Access Compliance Report

Public Rights-of-Way

(Curb Ramps)

Intersection ID: 31764	Main Street: CAROB_TREE_LN	Cross Street: STARNES_RANDALL_RD	Location: SW
ADA ID: A34517FEED09	Ramp Type: PerpDiag	Initial Pass/Fail: Fail	Overall Compliance: No
Severity Score: 8.75			
Codes/Mitigation Info/Possible Solution		Field Measurements/Component Compliance

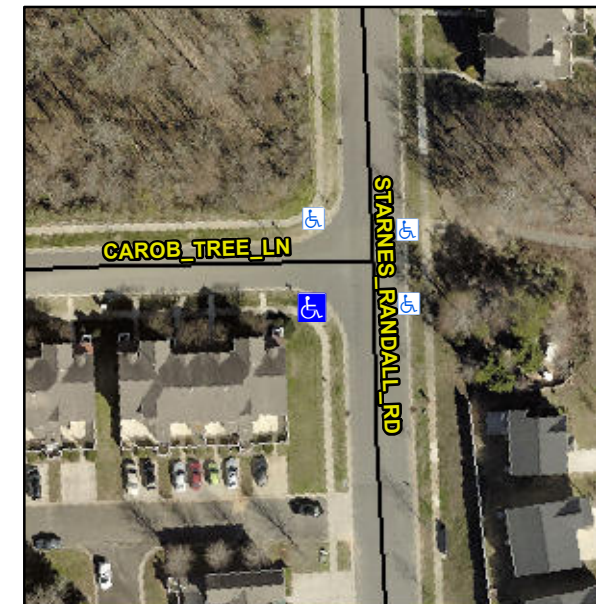
R304.5.1

Compliance	Description	Data	Compliance	Description	Data
N/A	Ramp Length (in)	92.0	Yes	Ramp Slope (%)	5.2
No	Ramp Width (in)	47.5	Yes	Ramp XSlope (%)	0.5
N/A	Flare Type LT	N/A	N/A	Flare Type RT	N/A
N/A	Flare Slope LT (%)	N/A	N/A	Flare Slope RT (%)	N/A
N/A	Flare Traversable LT?	N/A	N/A	Flare Traversable RT?	N/A
N/A	Landing Length (in)	N/A	N/A	DWS Provided?	N/A
N/A	Landing Width (in)	N/A	N/A	DWS Contrast?	N/A
N/A	Landing Slope (%)	N/A	N/A	DWS Length (in)	N/A
N/A	Landing X Slope (%)	N/A	N/A	DWS Full Width?	N/A
N/A	Landing Curb? (Y/N)	N/A	N/A	DWS Offset (in)	N/A
N/A	Shared Landing?	N/A			
N/A	Gutter Ponding?	N/A	N/A	Gutter Slope (%)	N/A
N/A	Gutter Lip Ht (in)	N/A	N/A	Gutter X Slope (%)	N/A
N/A	Painted X Walk1?	No	N/A	Painted X Walk2?	No
	X Walk 1 Direction	To E		X Walk 2 Direction	To N
N/A	X Walk 1 Width (in)	N/A	N/A	X Walk 2 Width (in)	N/A
	X Walk 1 Slope (%)	1.9		X Walk 2 Slope (%)	0.8
	X Walk 1 X Slope (%)	0.9		X Walk 2 X Slope (%)	1.5

Remove & Replace Curb Ramp With Two New Directional Ramps or Equivalent.
